## BOARD OF WORKS SPECIAL MEETING

Robert Pate, DLZ presented change orders 8-9-10 for the renovation project at City Hall located at 314 E Washington.

**AIA**<sup>®</sup>**Document G701™ – 2017****Change Order**

<b>PROJECT:</b> <i>(Name and address)</i> Greensburg City Hall Renovation 314 West Washington Street, Greensburg Indiana 47240	<b>CONTRACT INFORMATION:</b> Contract For: General Construction Date: 12/07/2020	<b>CHANGE ORDER INFORMATION:</b> Change Order Number: 008 Date: 04/16/2021
<b>OWNER:</b> <i>(Name and address)</i> Joshua Marsh, Mayor  314 West Washington Street, Greensburg Indiana 47240	<b>ARCHITECT:</b> <i>(Name and address)</i> DLZ Indiana, LLC  138 N. Delaware St, Indianapolis, IN 46204	<b>CONTRACTOR:</b> <i>(Name and address)</i> Construction Planning and Management, Inc. (CPM) 10053 N. Hague Rd, Indianapolis, Indiana 46256

Greensburg City Hall - 1 - 001 - ASSEMBLY ROOM (2  
Thus)

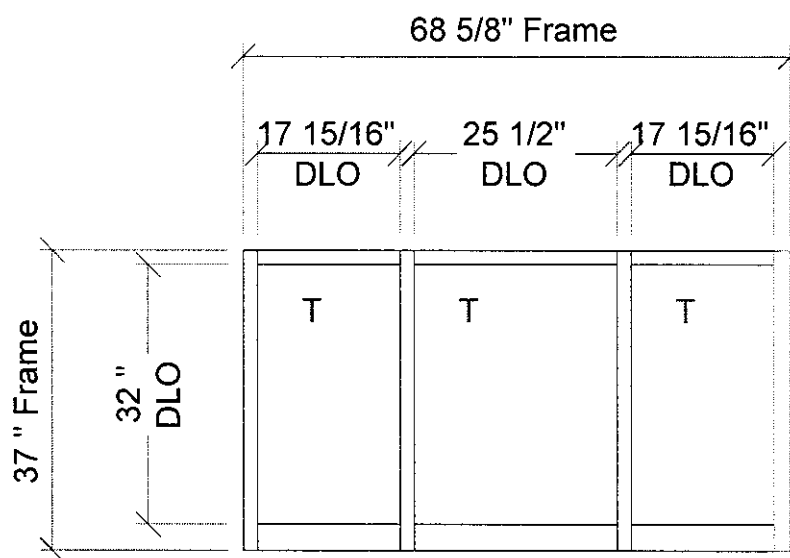
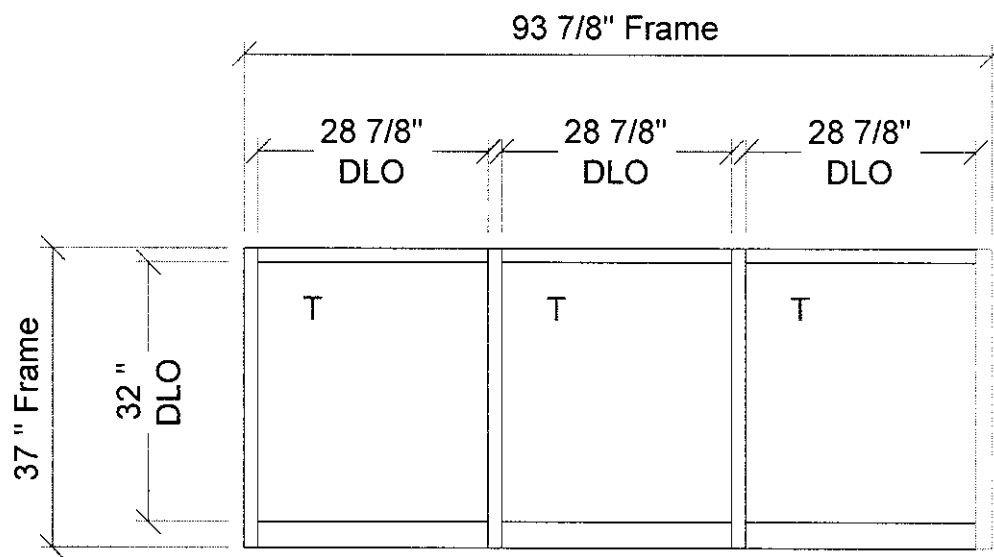
Section Title	Description of Proposed Materials
Aluminum Storefront & Entry Doors	Tubelite Aluminum storefront per G 5.2 R for A162 Assembly room. 1 ¾ Clear Anodized materials
Hardware	
Glazing	¾ inch Tempered Frosted Glass. PDF file must be provided for Greensburg Emblem on Glass., any associated artwork required is NOT included.
Caulking	Surrounding our scope of work only
Payment Terms	
Exclusions	Opening preparation and final cleaning.

Price Installed: \$6058.00

<b>DLZ</b> <small>ARCHITECTURE • ENGINEERING • PLANNING SURVEYING • CONSTRUCTION SERVICES</small> Select DLZ Company	RENOVATION OF THE GREENSBURG CITY HALL	REMARKS:	SKETCH NUMBER
			G5.1 (R)
	ASSEMBLY ROOM COUNCIL REMOVAL PLAN	PROJECT NO: 2063-1044-90	
		DATE: 03/31/2021	GENERAL

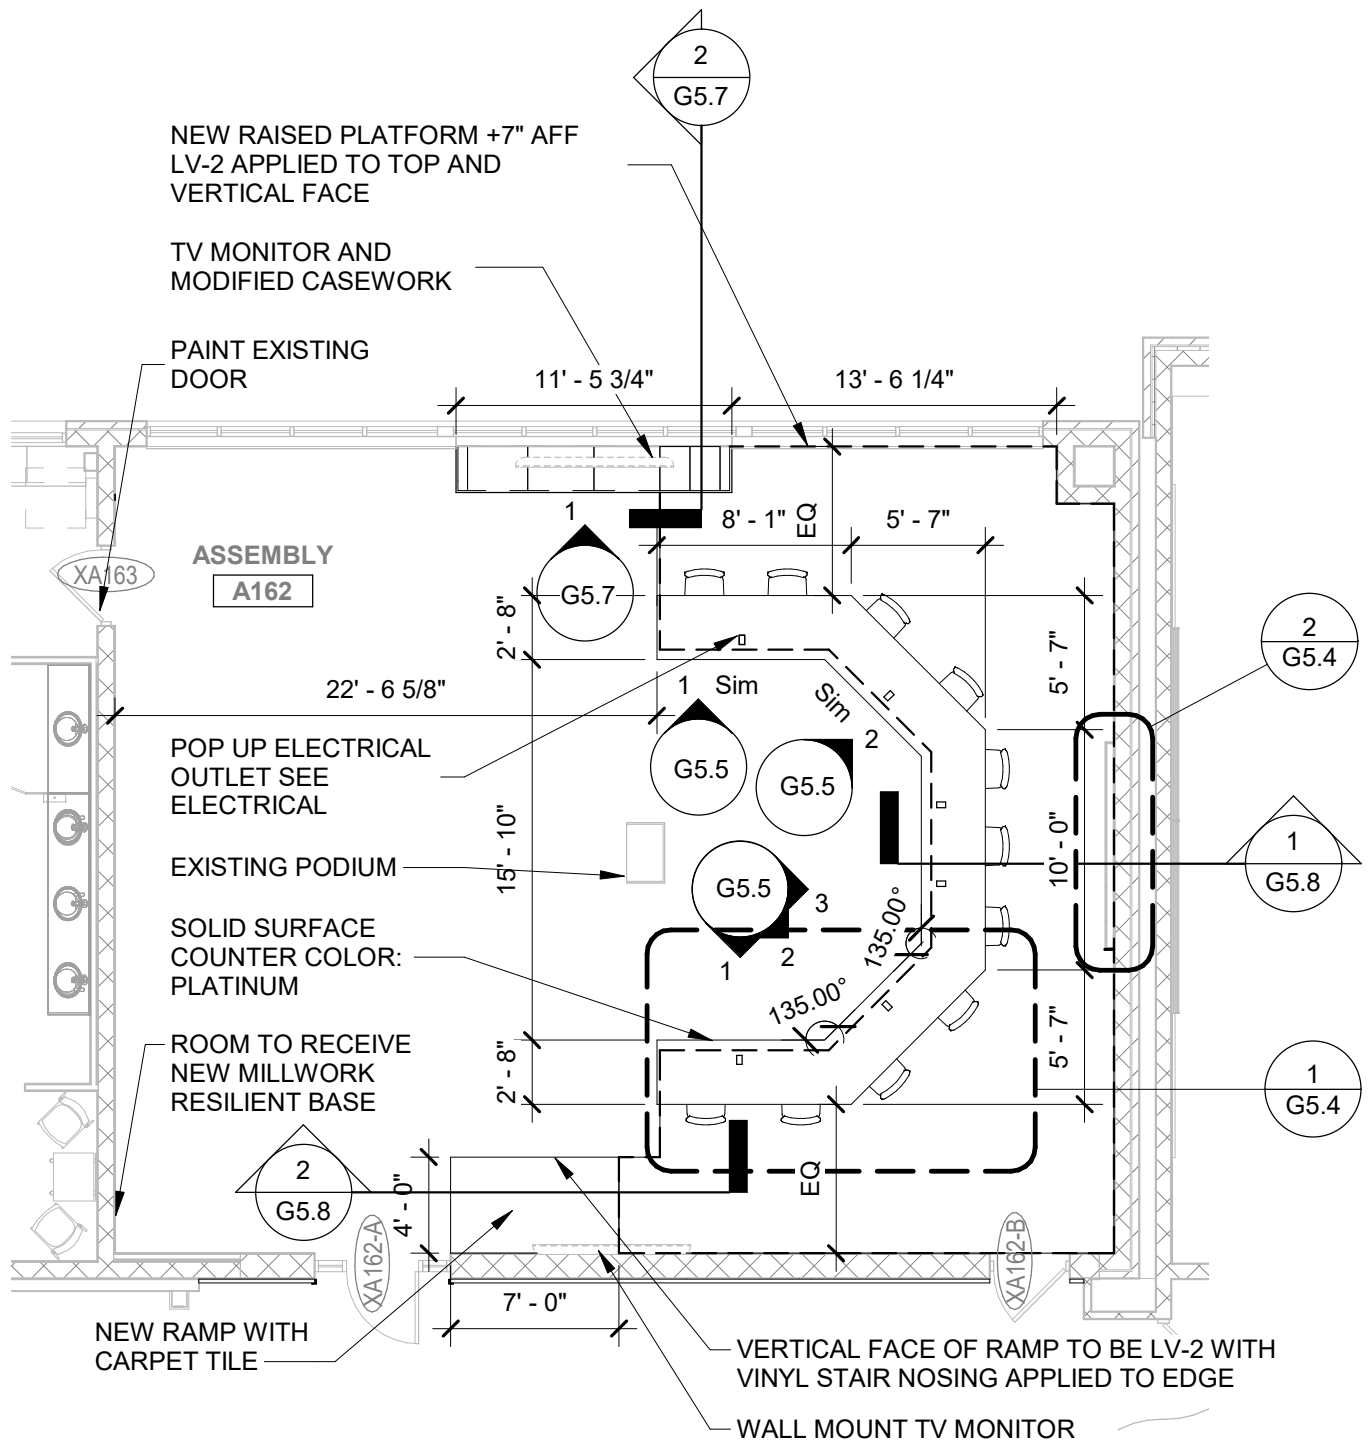
- a) Remove existing counter and casework complete including elevated floor, step, ramp, and accessories, see attached documents. Owner has right of first refusal. Contractor to install new storefront and council desk at location provided in attached documents.

- a) Remove existing counter and casework complete including elevated floor, step, ramp, and accessories, see attached documents. Owner has right of first refusal. Contractor to install new storefront and council desk at location provided in attached documents.

## ASSEMBLY ROOM A162 - ELEVATION PR 002 REVISED

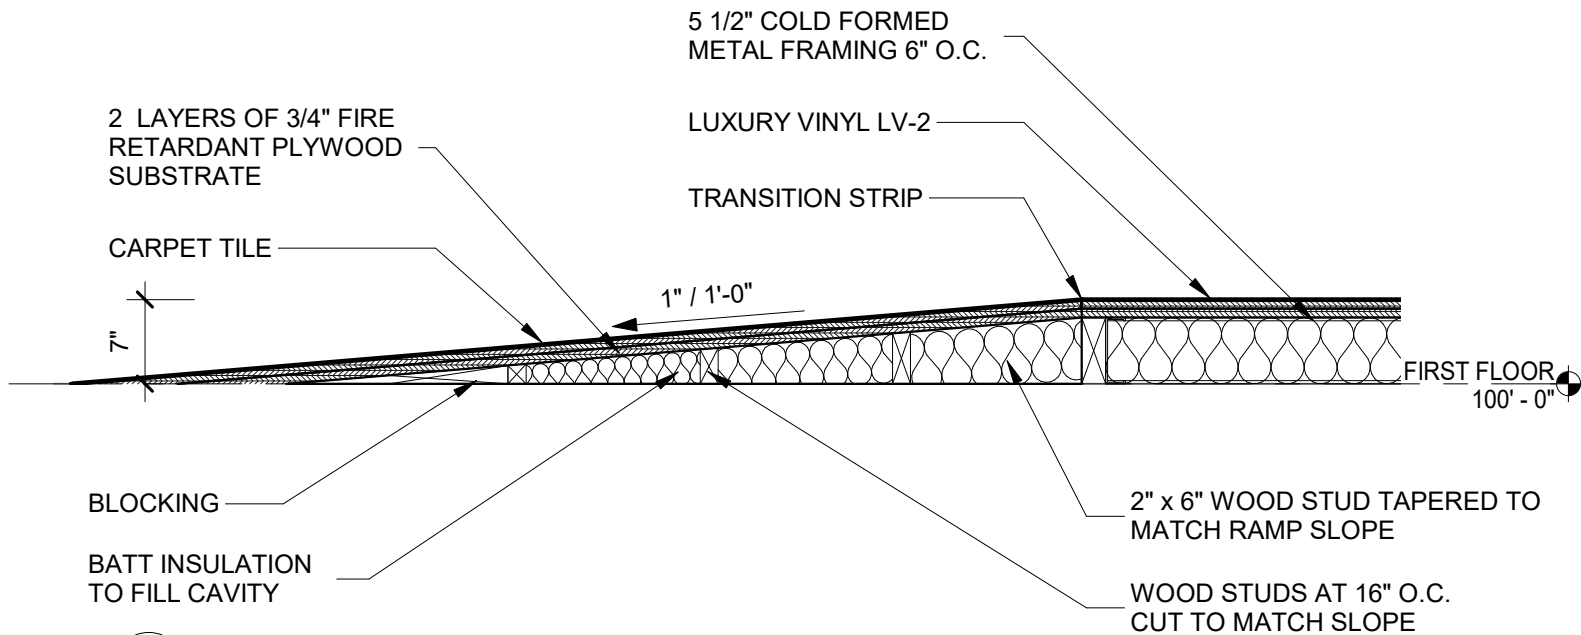
- f) Relocate LED downlights as shown on the drawings.
- g) Install new dimensional mosaic accent wall on East wall as shown in attached drawings.
- h) Revise casework along north wall of Assembly Room A162 as shown in in attached drawings.

- f) Relocate LED downlights as shown on the drawings.
- g) Install new dimensional mosaic accent wall on East wall as shown in attached drawings.
- h) Revise casework along north wall of Assembly Room A162 as shown in in attached drawings.

<p>ARCHITECTURE • ENGINEERING • PLANNING SURVEYING • CONSTRUCTION SERVICES</p> <p>Select DLZ Company</p>	<p>RENOVATION OF THE GREENSBURG CITY HALL</p> <p>ASSEMBLY ROOM COUNCIL DESK SECTION</p>	REMARKS:	SKETCH NUMBER
			G5.8 (R)
		PROJECT NO: 2063-1044-90	
		DATE: 03/31/2021	GENERAL

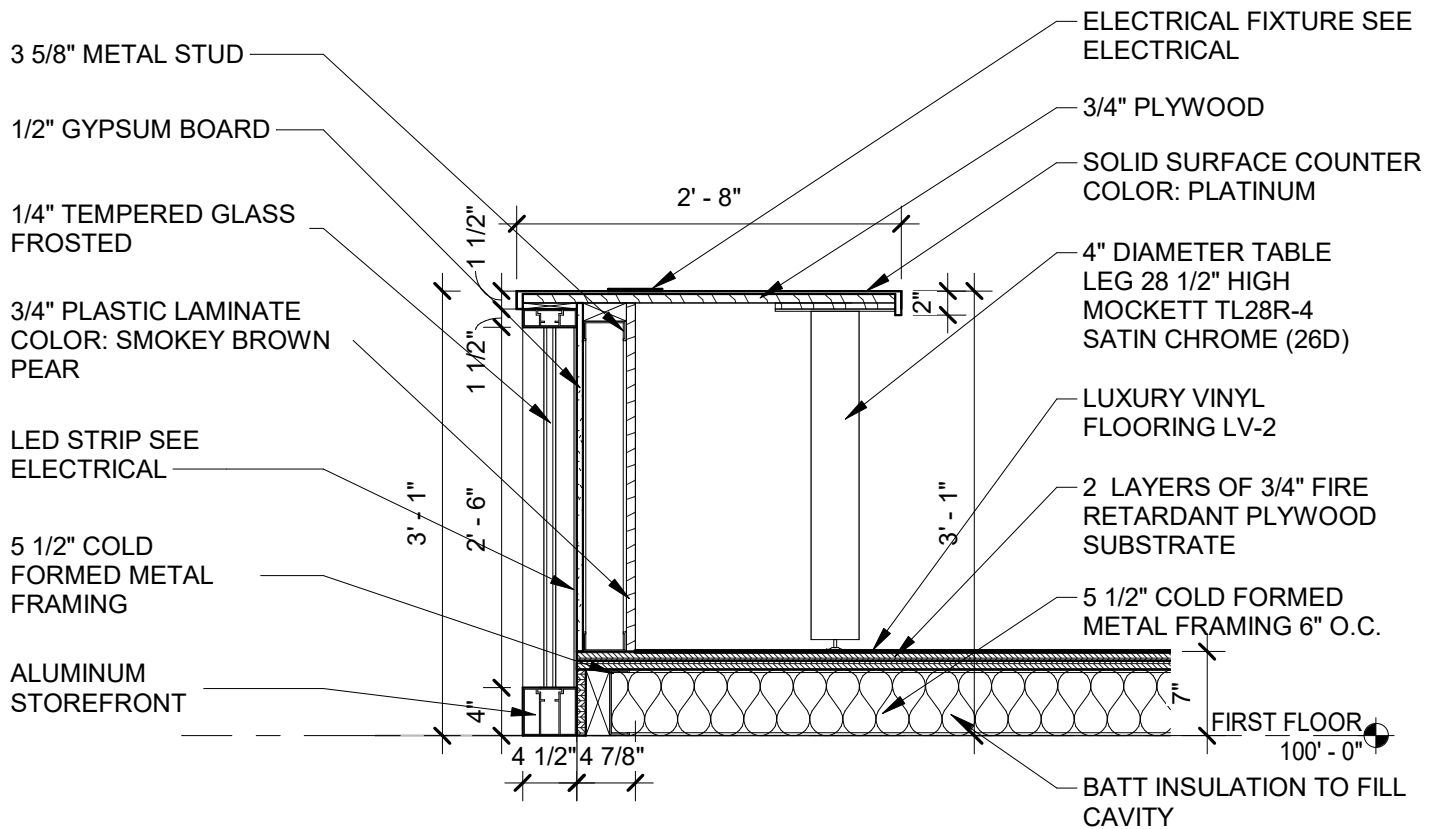
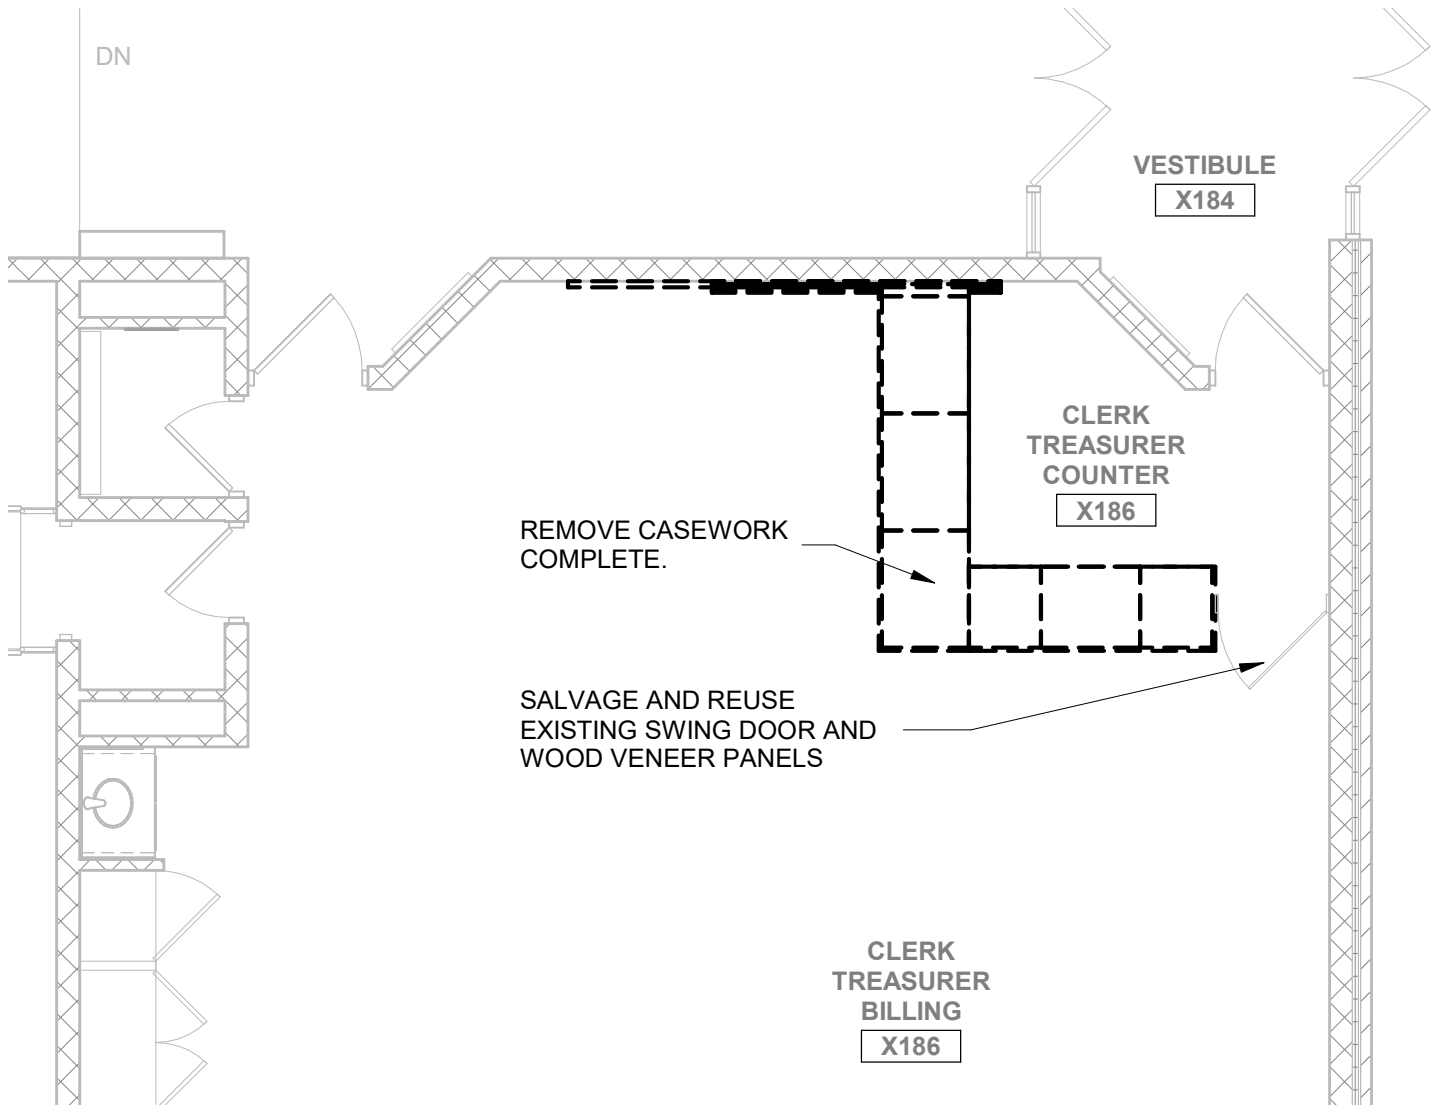
Add labor and material for nosing and side of platform LVT for newly built raised platform.

**ADD: \$500.00**

<p>ARCHITECTURE • ENGINEERING • PLANNING SURVEYING • CONSTRUCTION SERVICES</p> <p>Select DLZ Company</p>	RENOVATION OF THE GREENSBURG CITY HALL	REMARKS:	SKETCH NUMBER
			G5.9 (R)
	CLERK TREASURER COUNTER REMOVAL PLAN	PROJECT NO: 2063-1044-90	
		DATE: 03/31/2021	GENERAL

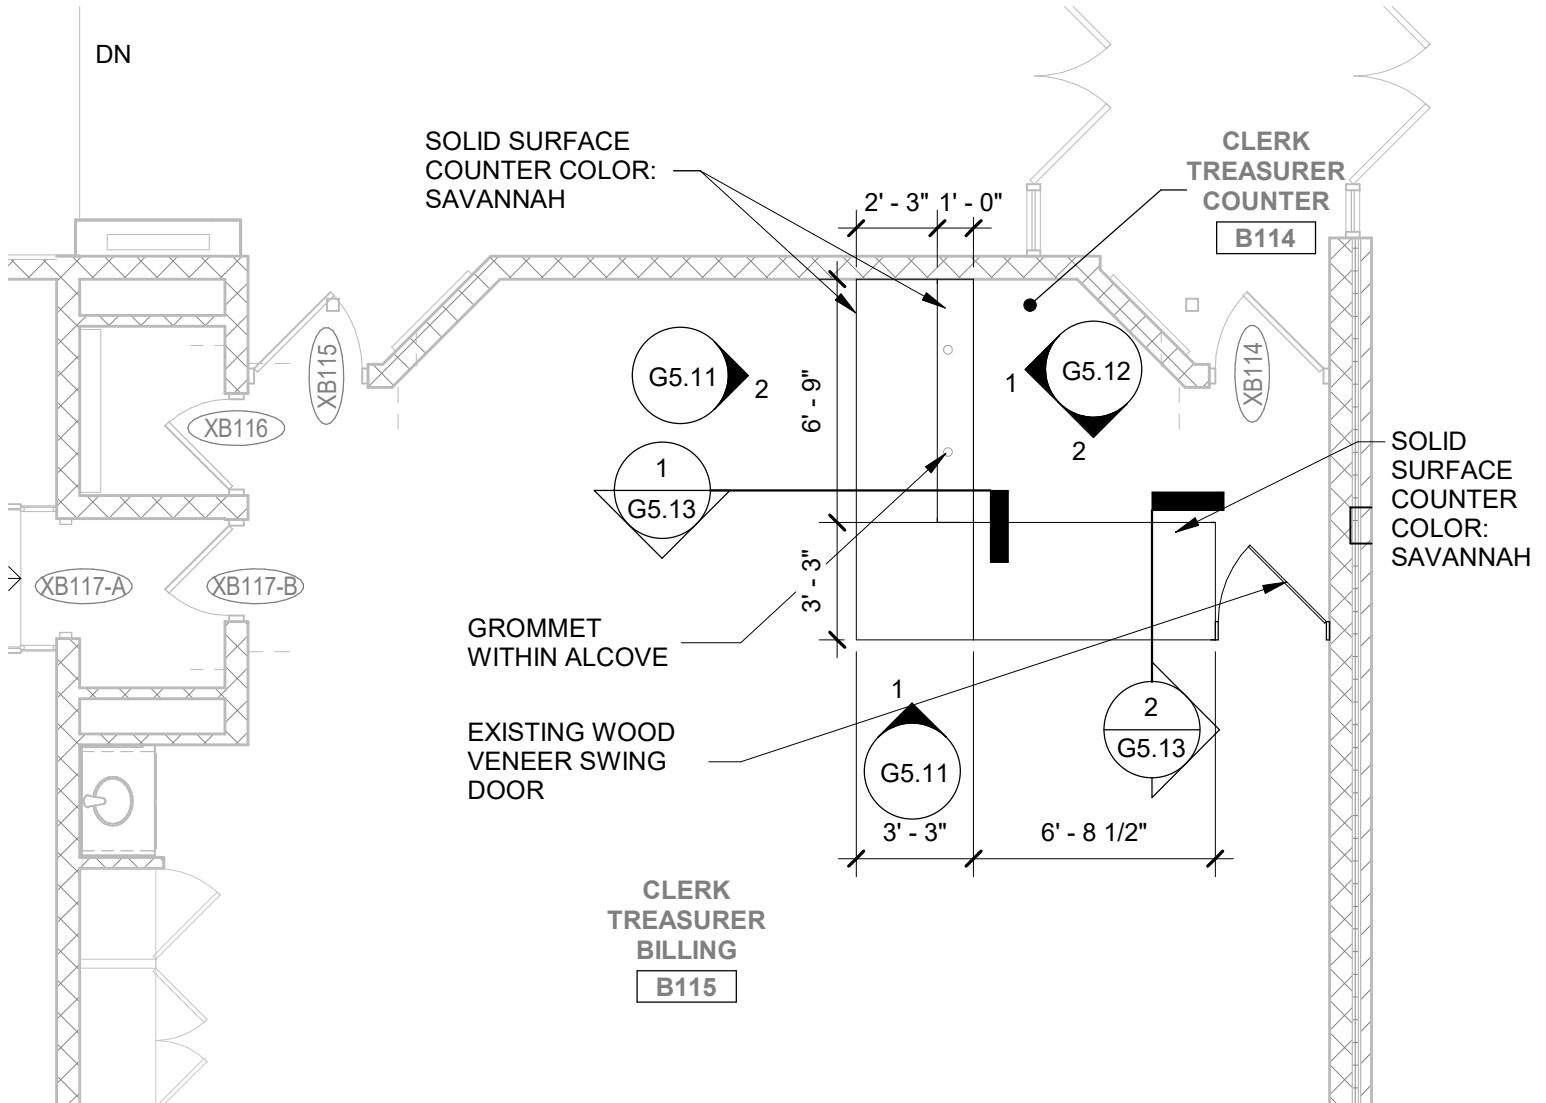
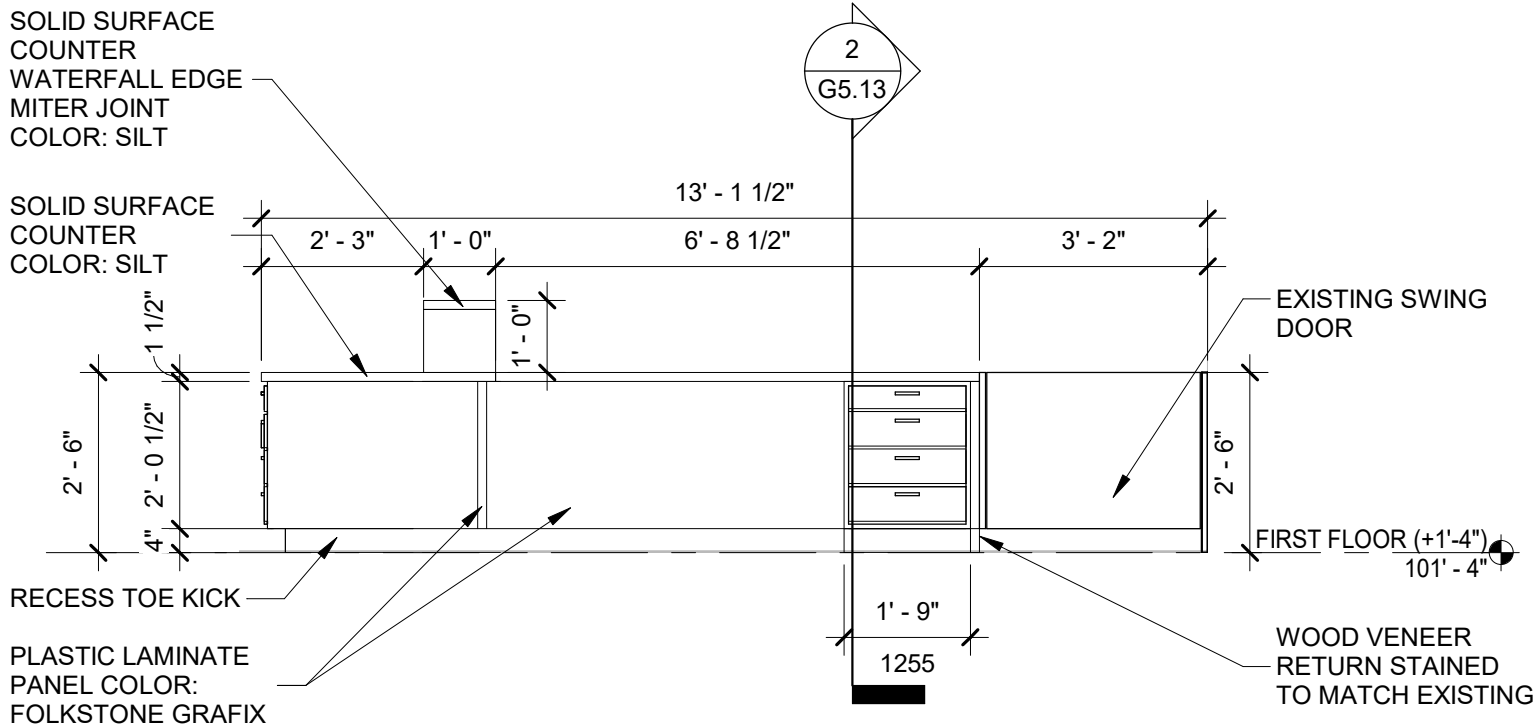
- a) Remove existing Clerk Treasurer reception casework, counter and swing door complete, see attached documents.
- b) Install casework with solid surface counter and swing door as shown in attached drawings.

- a) Remove existing Clerk Treasurer reception casework, counter and swing door complete, see attached documents.
- b) Install casework with solid surface counter and swing door as shown in attached drawings.
